Seismic Walkdown Checklist (SWC)

Equipment ID No. 300043 per 9/17/2012 ~~30S37-PANEL~~ Equip. Class¹² (20) Control Panels & Cabinets
 Equipment Description HPCI Turbine Aux Lube Oil Pump Starter
 Location: Bldg. Reactor Floor El. 88 Room, Area R3-13
 Manufacturer, Model, Etc. (optional but recommended) _____

300943 GM 9/17/2012
 Equipment ID No. 30S37-PANEL Equip. Class¹² (20) Control Panels & Cabinets
 Equipment Description HPCI Turbine Aux Lubr Oil Pump starter

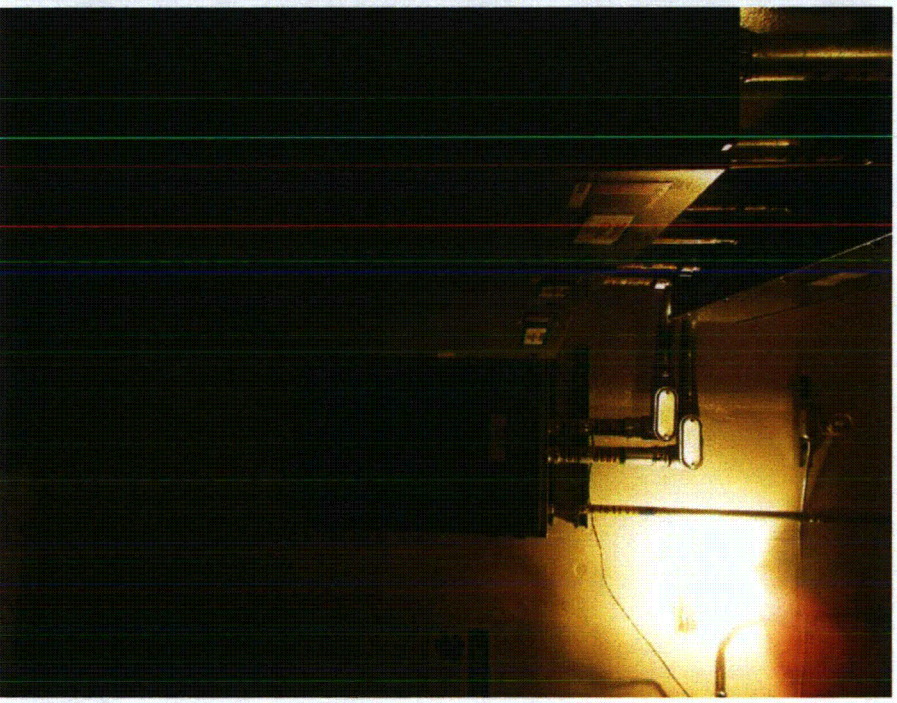
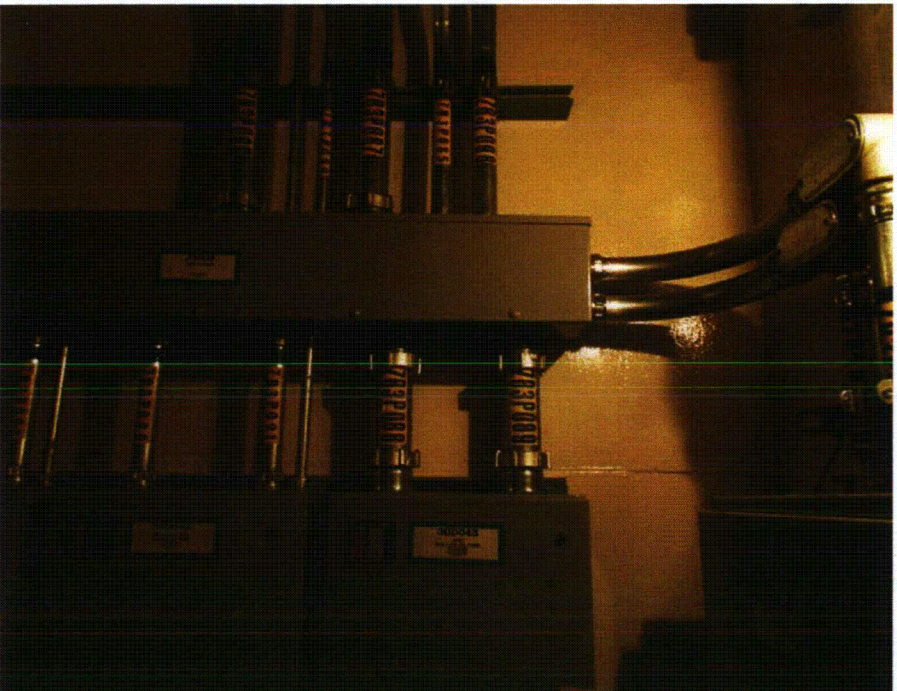
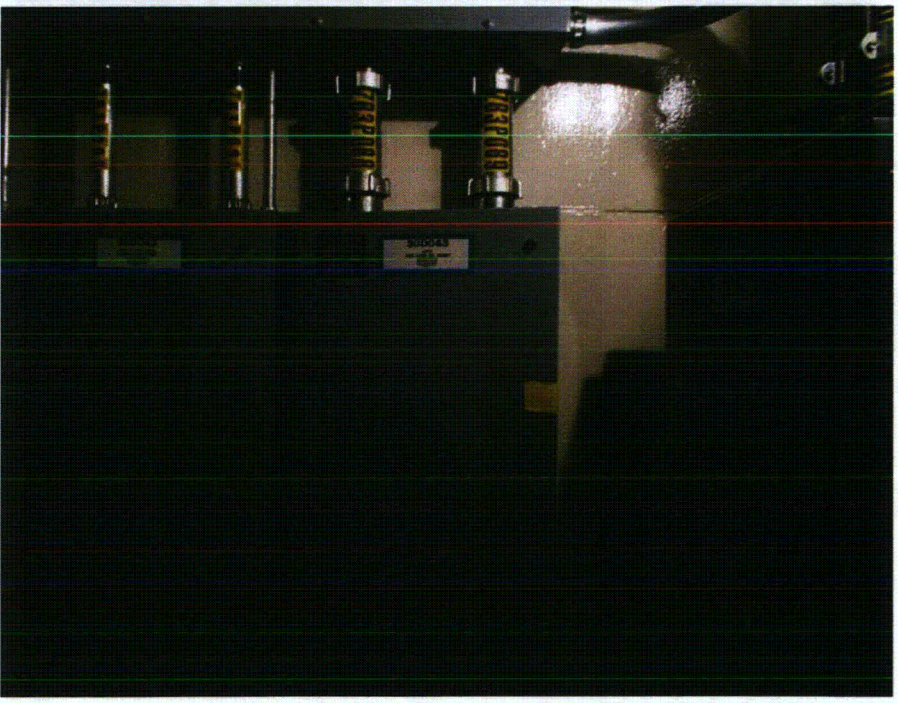
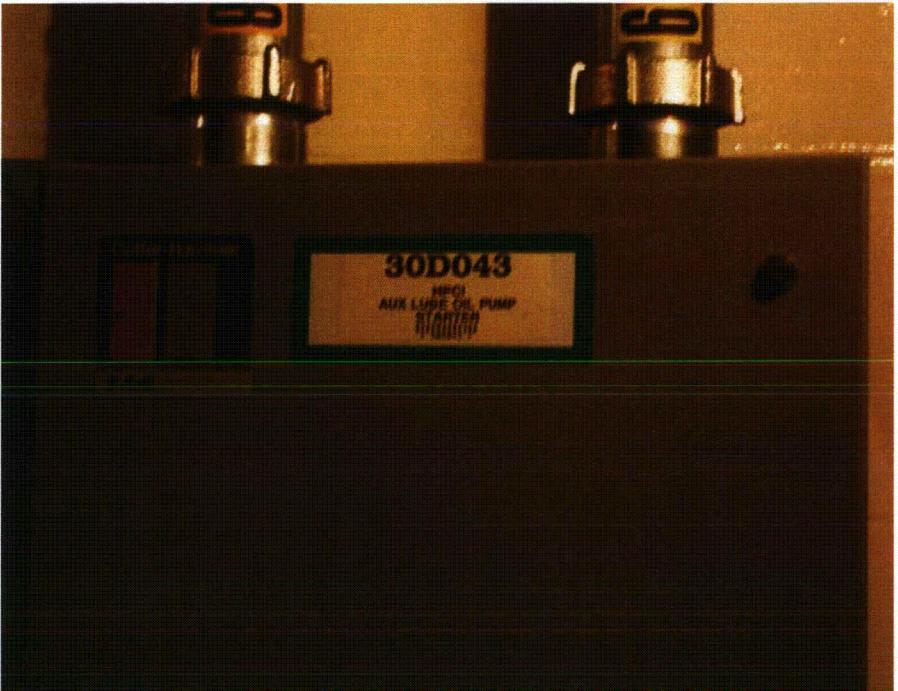
Noted that cabinet was open for in-progress work, but was taped to prevent full opening of front cover; judged not a seismic concern

Equipment ID No. 30P036 & 30S038 Equip. Class¹² (05) Horizontal Pumps

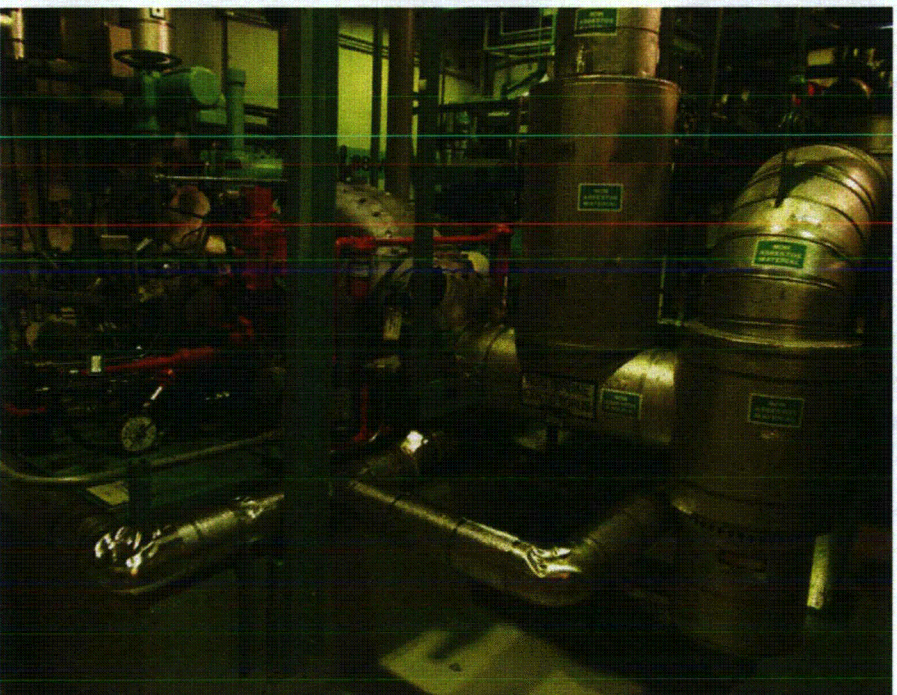
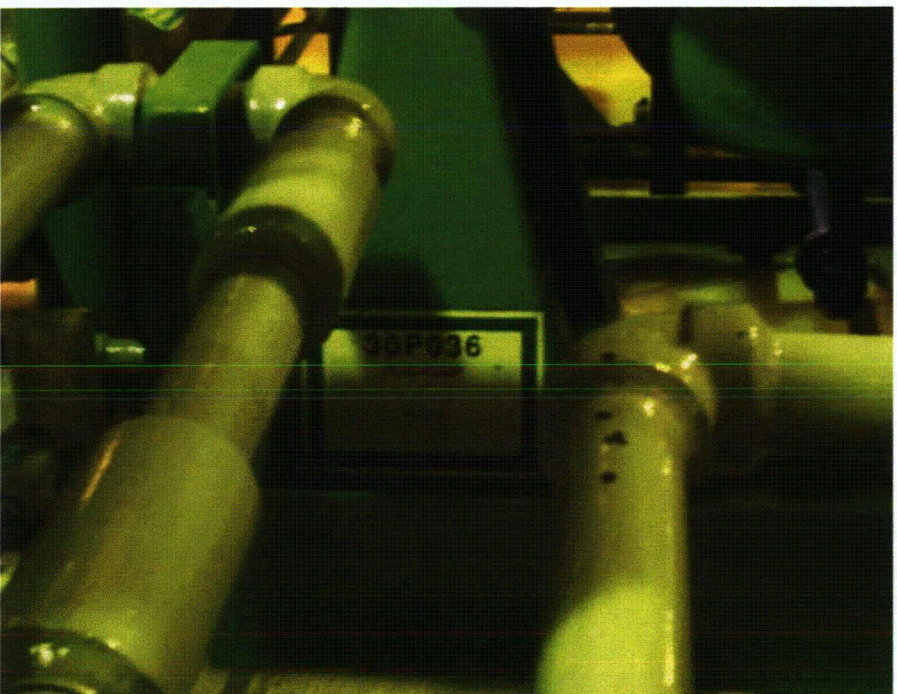
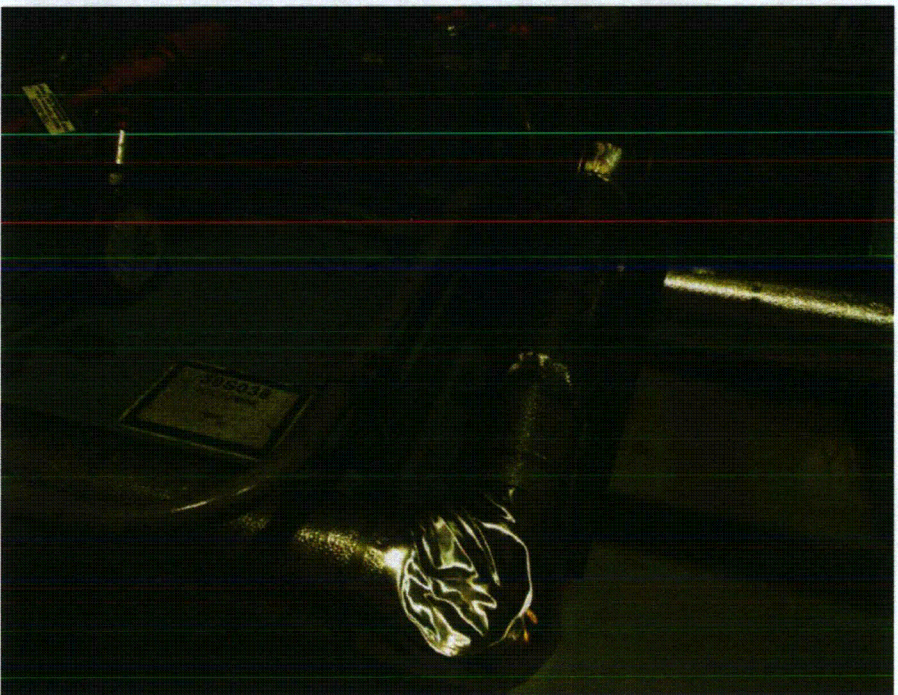
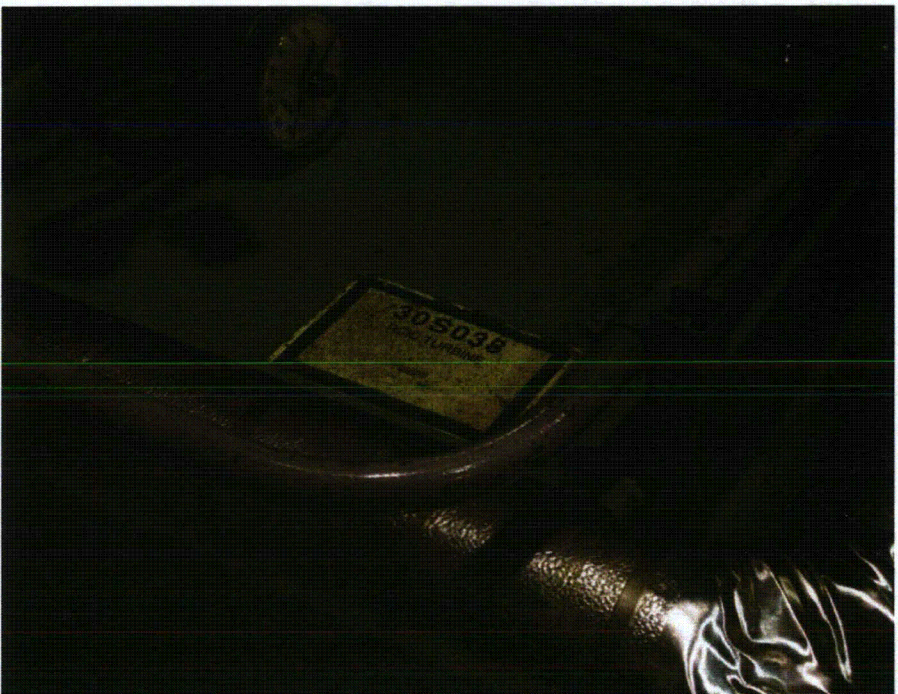
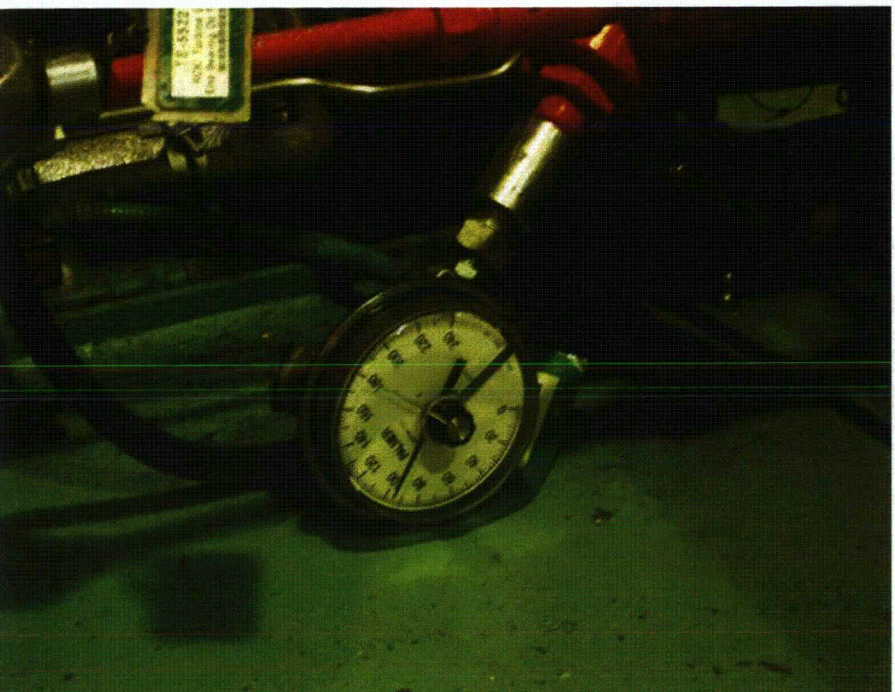
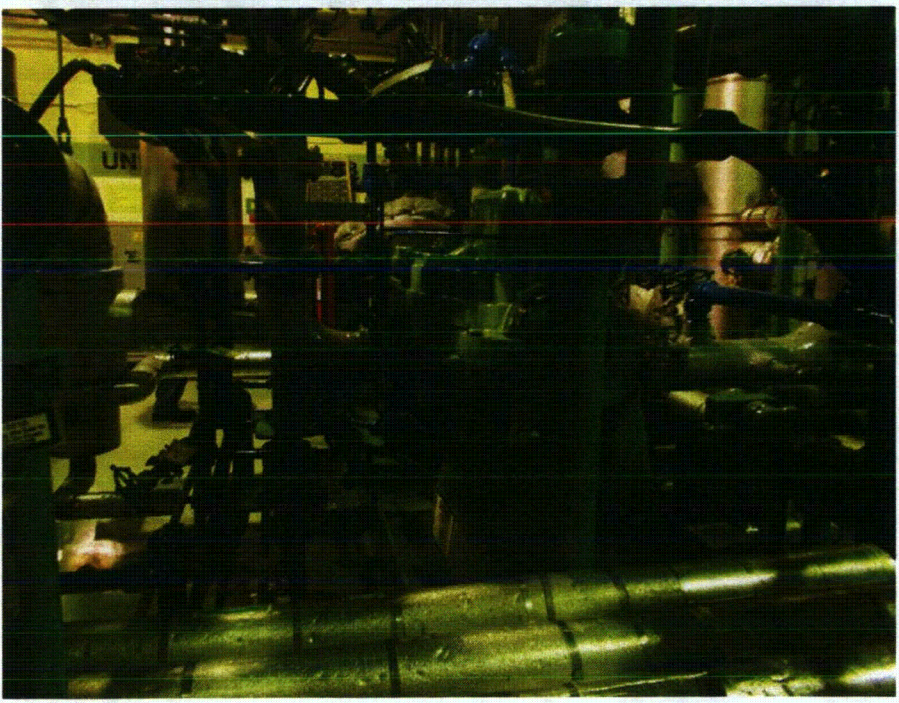
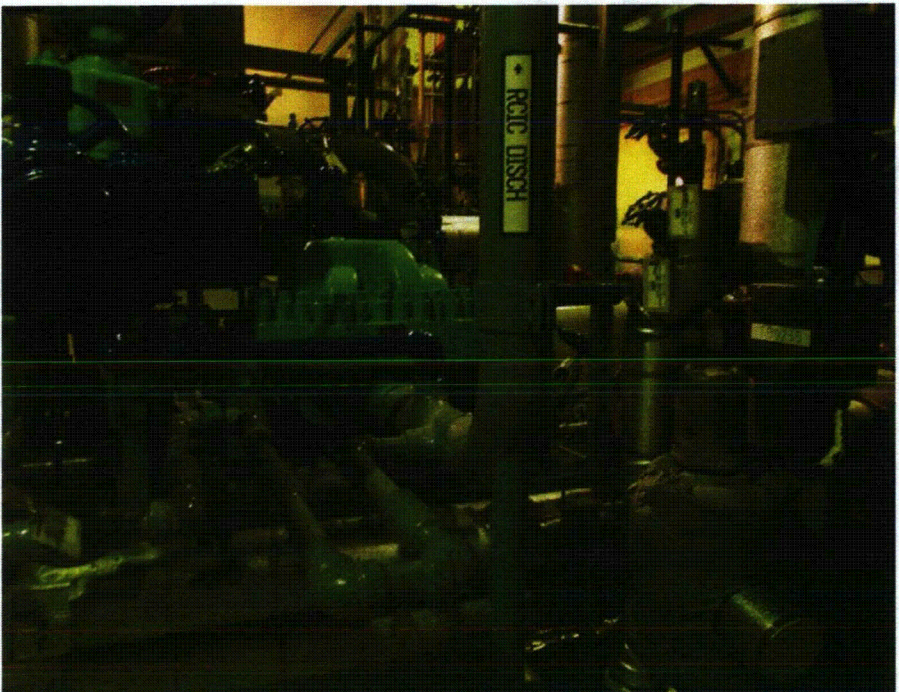
gauge
Turbine governor and bearing oil temperature detector in contact w/ turbine skid; judged not to affect safety function of equipment

Block wall # 16-2 safety-related per PBAPS specification No. M-701, Rev. 1

Equipment ID No. 30X030 Equip. Class¹² (04) Transformers

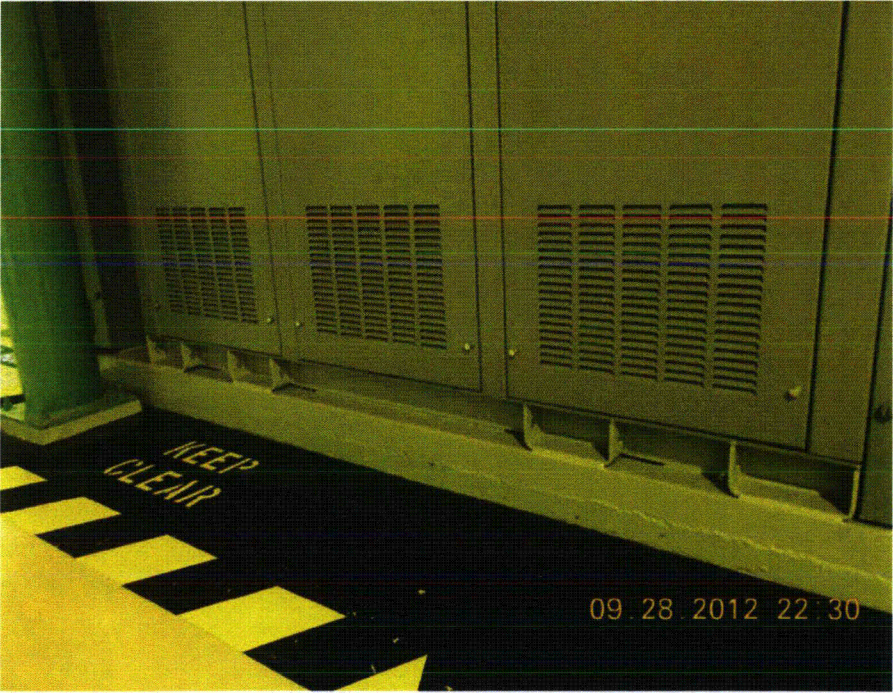
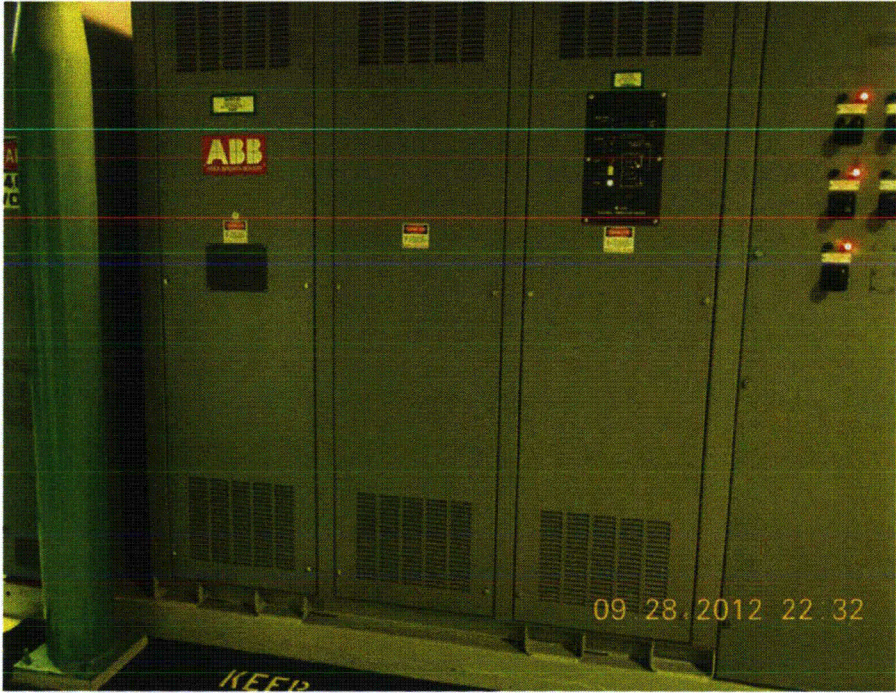
Masonry wall reinforcement needs to be verified. Walls 410.6-410.10 are safety related per Spec M-701, Rev. 1. 11/8/12

Equipment ID: 3AE058

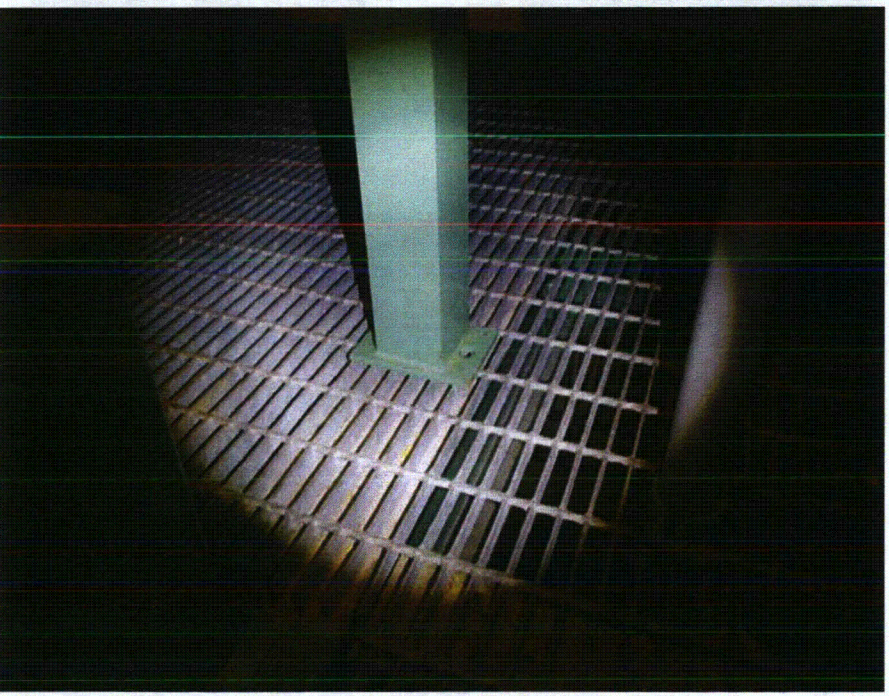
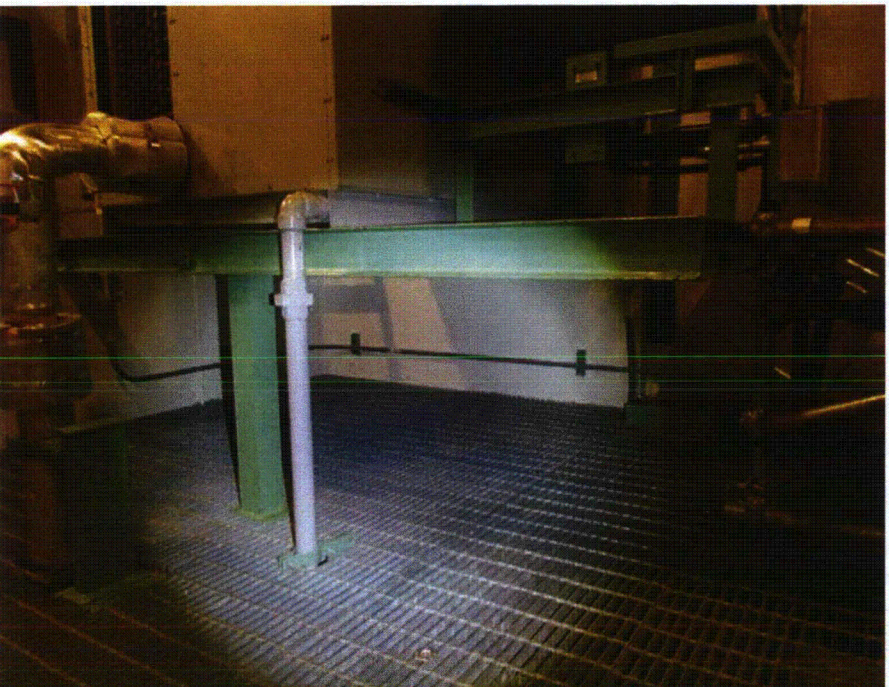
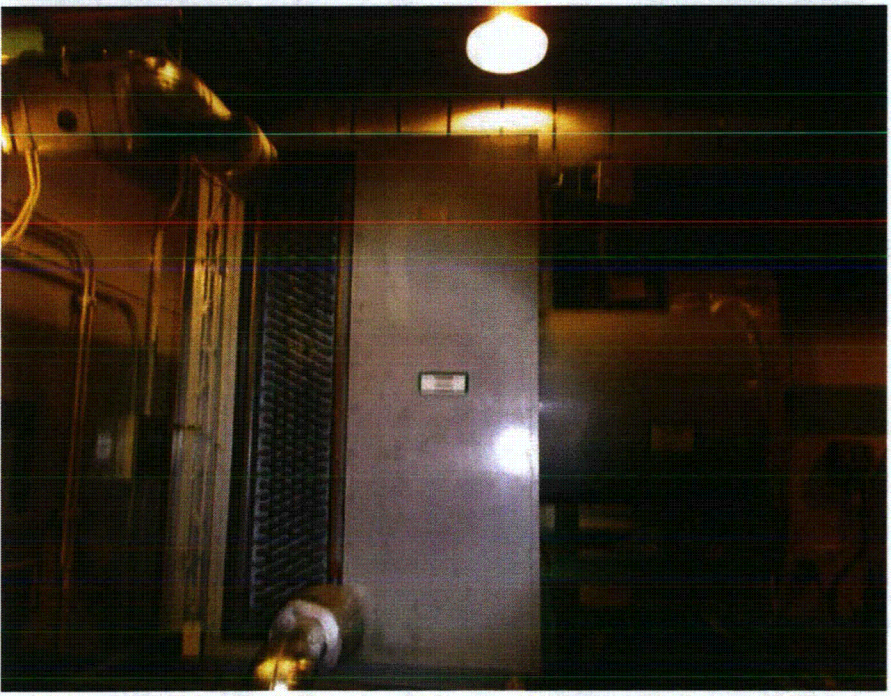
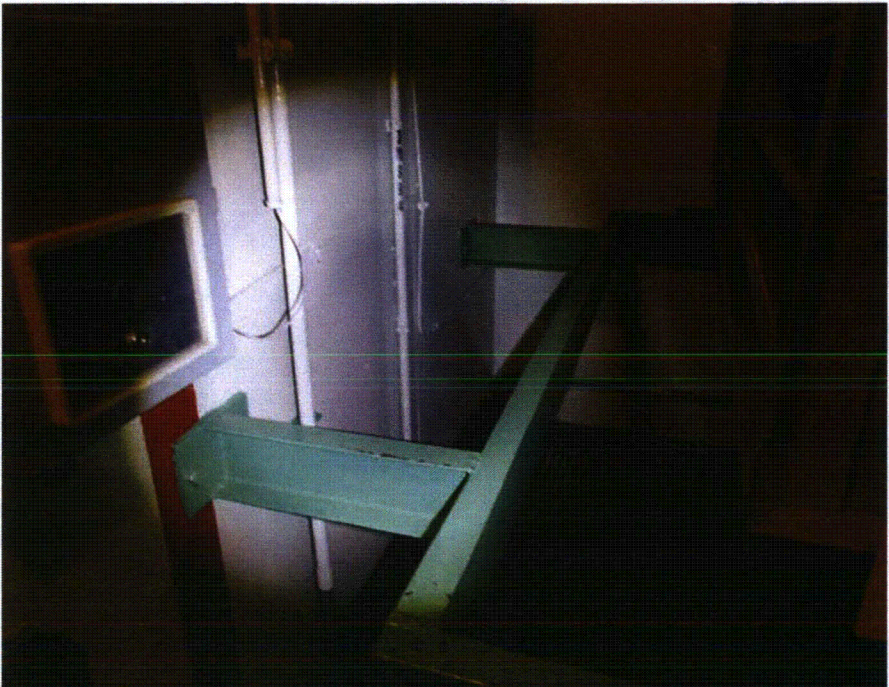
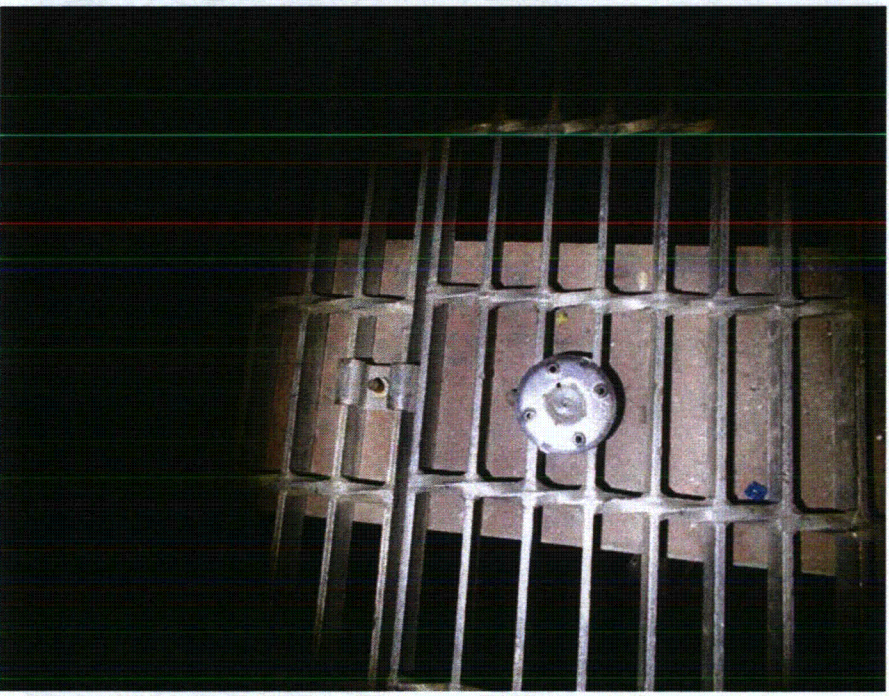
2. Is the anchorage free of bent, broken, missing or loose hardware? Y N U N/A
Detail D on Dwg indicates 5/8" bolts. Plate bears on grating w/ no bolts. PS Anchorage evaluated in PS-0922 Rev. 0 + missing bolt is acceptable.
